## Edition 3/2007

### This edition contains:

## Conversion of hub cap spanner

## Conversion of hub cap spanner

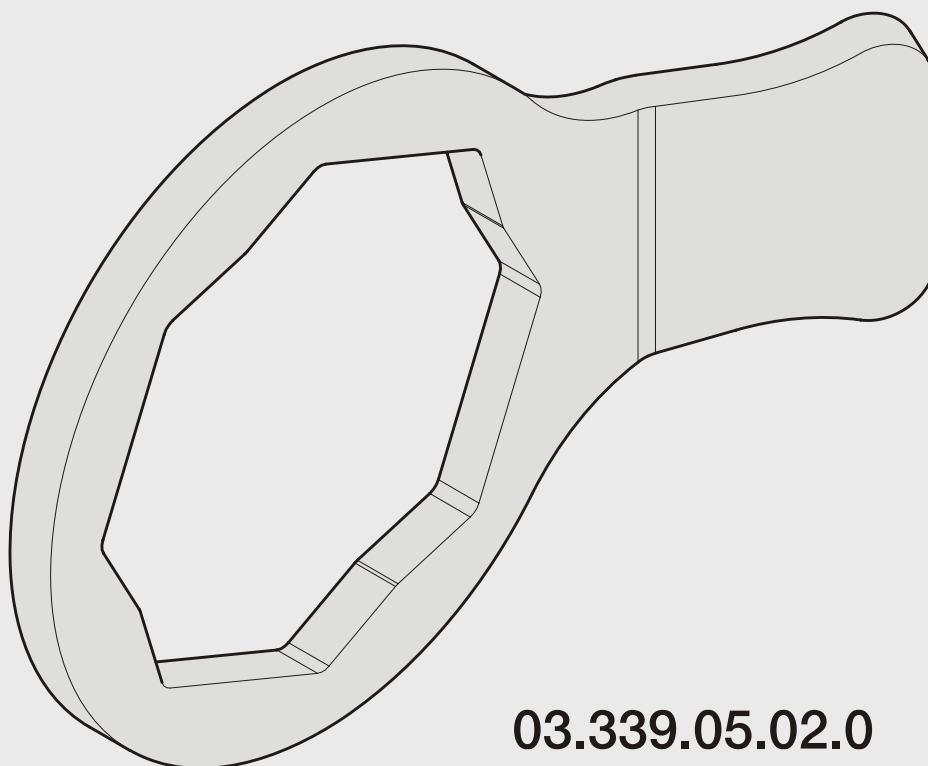
With the launch of the ECO Plus 2, there have been changes to the code numbers for versions 03.339.05.02.0 and 03.339.05.07.0!

The spanner 03.339.05.07.0 (formerly BPW shape, size 120) now has the shape of the 03.339.05.02.0 version (octagonal, size 120)

The spanner 03.339.05.02.0 (formerly octagonal, size 120) now has a revised shape of the 03.339.05.07.0 version which means it can be used for ECO Plus 2 with 120 / 0 offset.
